RE: Bond Release 9 to Permit 37

This submittal contains a response to your letter to us dated July 8, 2014. In this letter you listed technical deficiencies that must be addressed before the bond release application for Permit 37 can be approved. Any changes that have been made within the text portion of the application have been highlighted in **green**. Below is a listing of the deficiencies followed by our response:

Attachment VII – Seeding Map

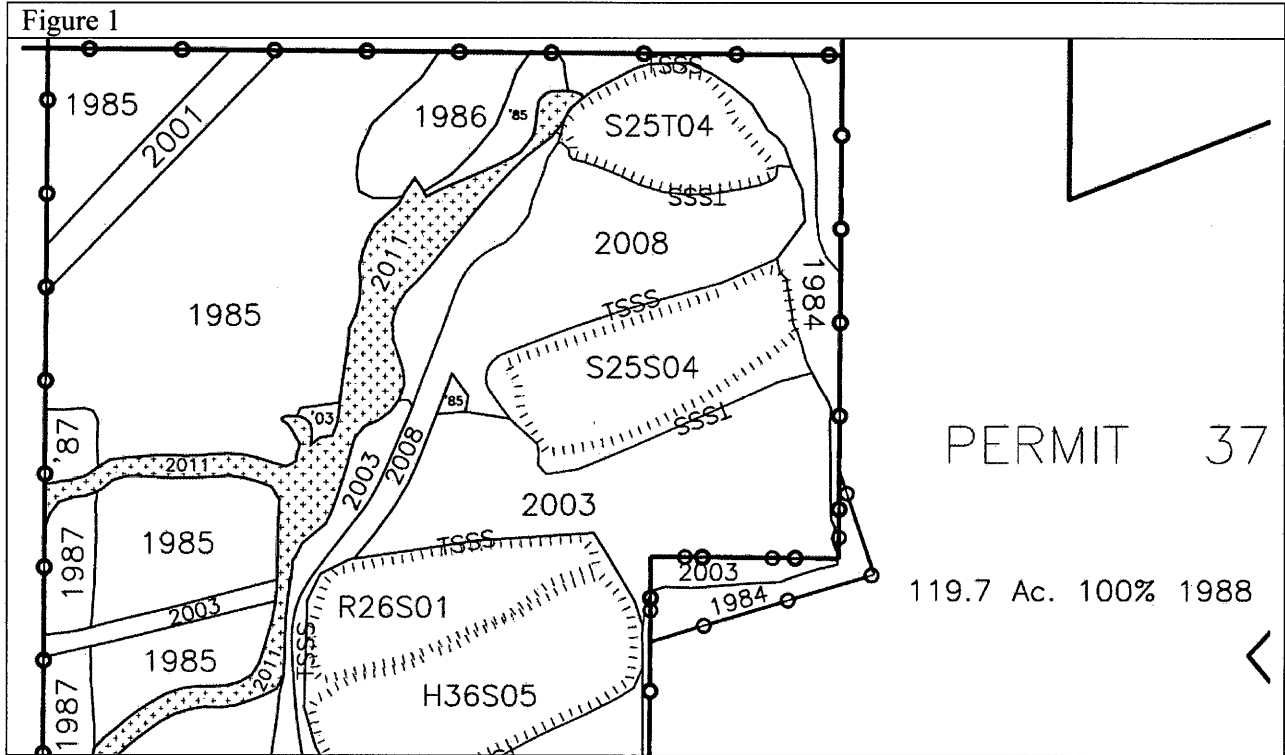
13. Attachment VII, Seeding Map shows areas south and east of the seeding line as being seeded in 2003. Please accurately depict the actual seeding dates on this map. Please also explain why the 2011 and earlier Annual Mine Maps show the southern and eastern portion of this tract as having the 10 revegetation period initiated in 1984 rather than 1981 as shown in Figure 1 below. Explain why this initiation date was changed on this area with the 2012 Annual Mine Map. (GAW)

The first submittal of the 2012 Annual Map, dated March 15, 2013, shows the area in question to be seeded in 1984. On the second submittal of the 2012 Annual Map, dated January 9, 2014, the area in question is shown as being seeded in 1981. The change came about in response to deficiency No. 6 of the PSC Bond Release 9 to Permit 37 Technical 2 Review Letter dated November 20, 2013. This deficiency requested a review of the reclamation activities on this tract to clarify and accurately reflect the 10-year revegetation period for this area. As a result of our review of old aerial photos, annual maps and grade approvals, it was determined that the southern portion of this tract was seeded in 1981 not 1984. In BNI's Response letter, dated January 14, 2014, to the Technical 2 Review Letter, we stated that the 2012 Annual Map was updated to reflect the 1981 seeding date. The 2012 Annual Map was approved on March 6, 2014, which includes the 1981 seeding date for this portion of the bond release tract.
